PROJECT NAME: MANCHESTER-RUTLAND TOWN	PLOT DATE: 1/14/2016
PROJECT NUMBER: NH SURF(50)	DRAWN BY: B. KIPP
FILE NAME: p14v200.dgn	DESIGNED BY: B. KIPP
PROJECT LEADER: M. FOWLER	CHECKED BY: M. FOWLER
TRAFFIC SIGNAL SYSTEM SHEET 4	SHEET 88 OF 105

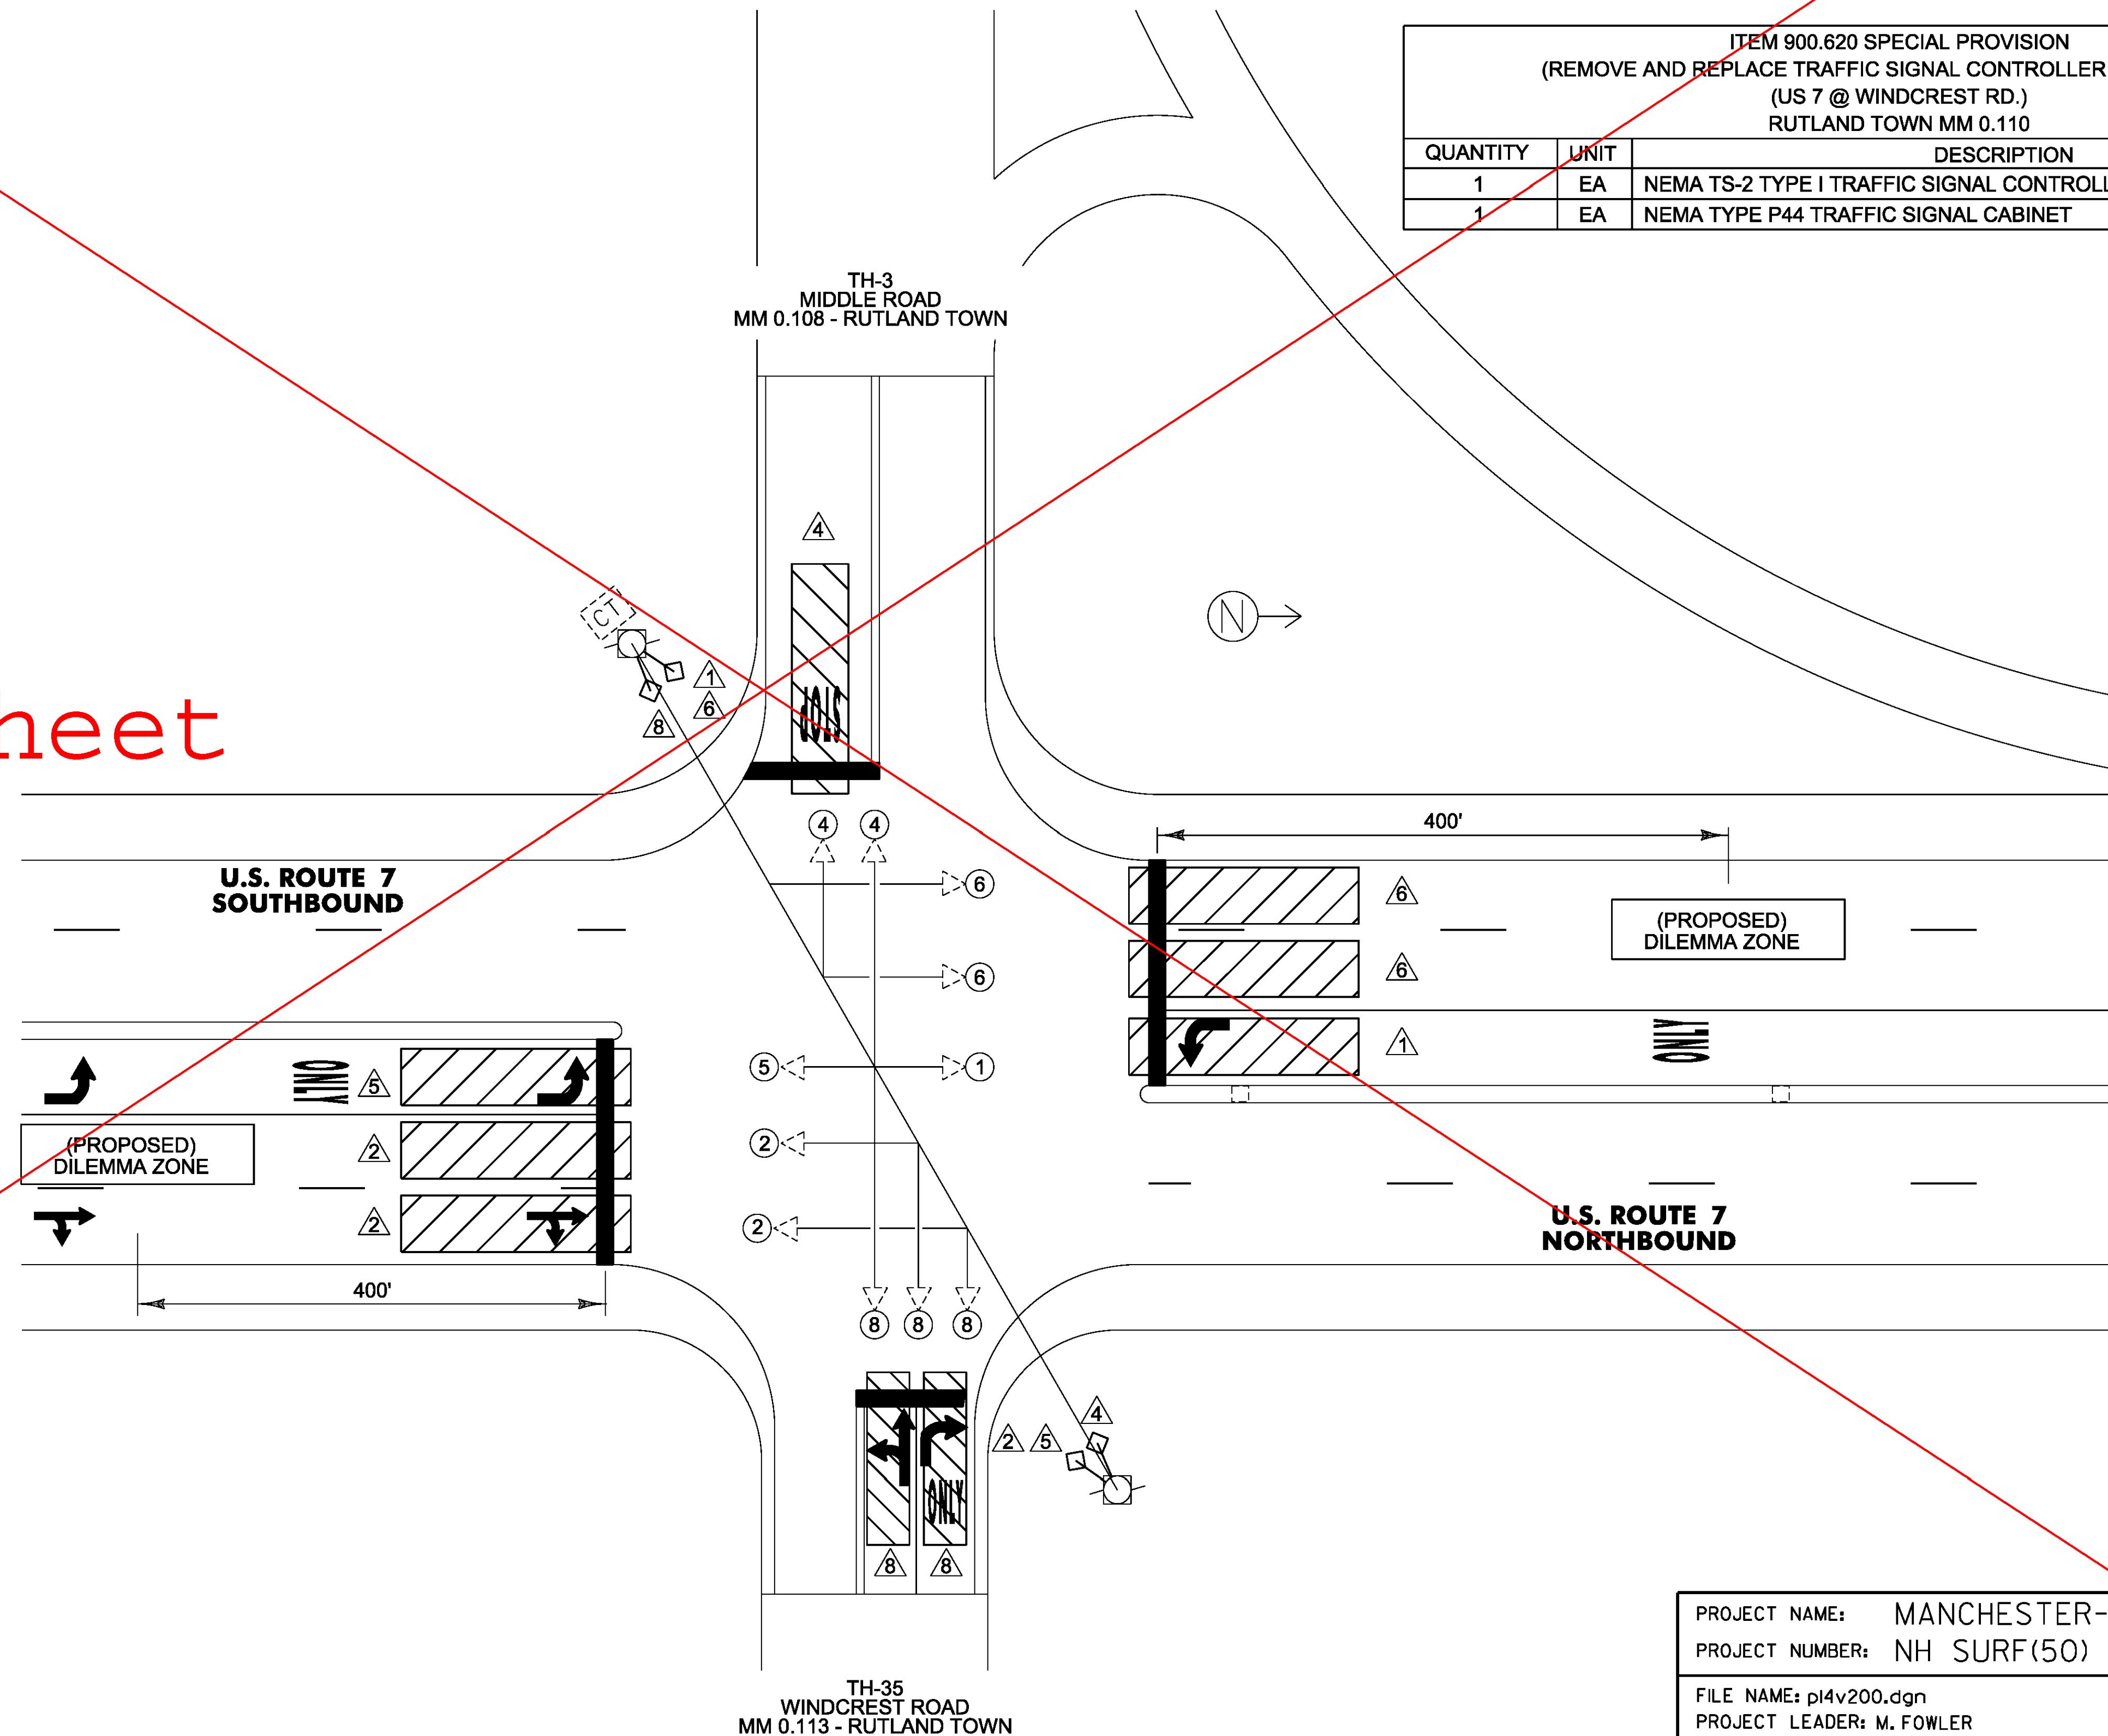
see revised sheet
